Access Compliance Report

Public Rights-of-Way

(Curb Ramps)

Intersection ID: 5090	Main Street: EDMONTON_PL	Cross Street: SARNIA_PL	Location: NW
ADA ID: 9F2C592D866E	Ramp Type: Perp	Initial Pass/Fail: Fail	Overall Compliance: No
Severity Score: 13.75			
Codes/Mitigation Info/Possible Solution		Field Measurements/Component Compliance

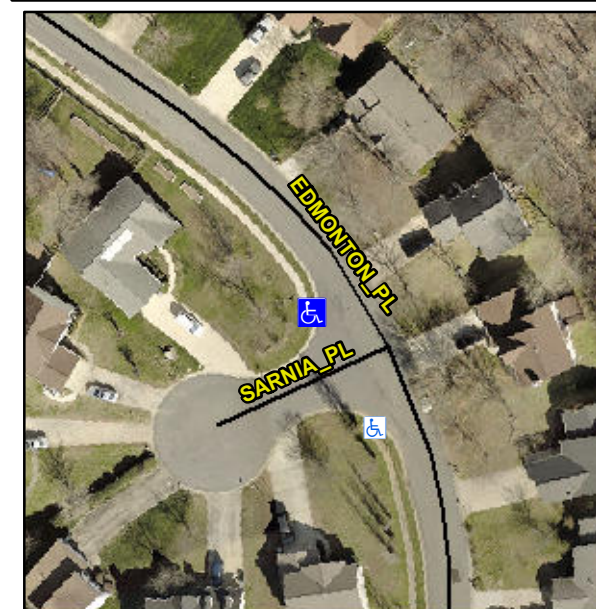
R304.2.2, R304.5.3

Compliance	Description	Data	Compliance	Description	Data
N/A	Ramp Length (in)	47.0	No	Ramp Slope (%)	11.3
Yes	Ramp Width (in)	48.0	No	Ramp XSlope (%)	4.7
N/A	Flare Type LT	N/A	N/A	Flare Type RT	N/A
N/A	Flare Slope LT (%)	N/A	N/A	Flare Slope RT (%)	N/A
N/A	Flare Traversable LT?	N/A	N/A	Flare Traversable RT?	N/A
N/A	Landing Length (in)	N/A	N/A	DWS Provided?	N/A
N/A	Landing Width (in)	N/A	N/A	DWS Contrast?	N/A
N/A	Landing Slope (%)	N/A	N/A	DWS Length (in)	N/A
N/A	Landing X Slope (%)	N/A	N/A	DWS Full Width?	N/A
N/A	Landing Curb? (Y/N)	N/A	N/A	DWS Offset (in)	N/A
N/A	Shared Landing?	N/A			
N/A	Gutter Ponding?	N/A	N/A	Gutter Slope (%)	N/A
N/A	Gutter Lip Ht (in)	N/A	N/A	Gutter X Slope (%)	N/A
N/A	Painted X Walk1?	No	N/A	Painted X Walk2?	N/A
	X Walk 1 Direction	To S		X Walk 2 Direction	N/A
N/A	X Walk 1 Width (in)	N/A	N/A	X Walk 2 Width (in)	N/A
	X Walk 1 Slope (%)	5.6		X Walk 2 Slope (%)	N/A
	X Walk 1 X Slope (%)	1.8		X Walk 2 X Slope (%)	N/A

Remove & Replace Entire Ramp.
